Date of Issue: June 2018

Affected Publication: API Specification 5B, *Threading, Gauging, and Inspection of Casing, Tubing, and Line Pipe Threads*, December 2017

Errata 1

Figure 3—Buttress Casing Thread Form and Dimensions (Casing sizes 16 in. and longer)

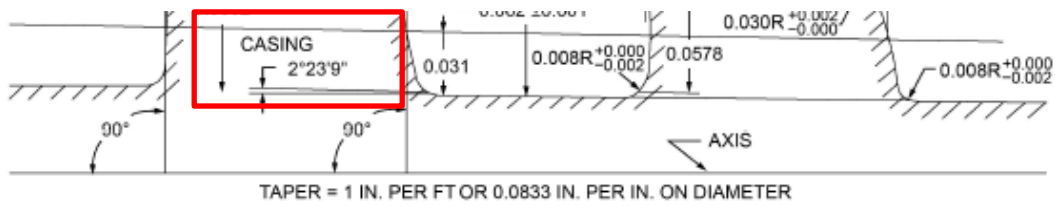
Figure 3: The title shall be changed to the following:

The figure shall be updated as indicated within the red box:
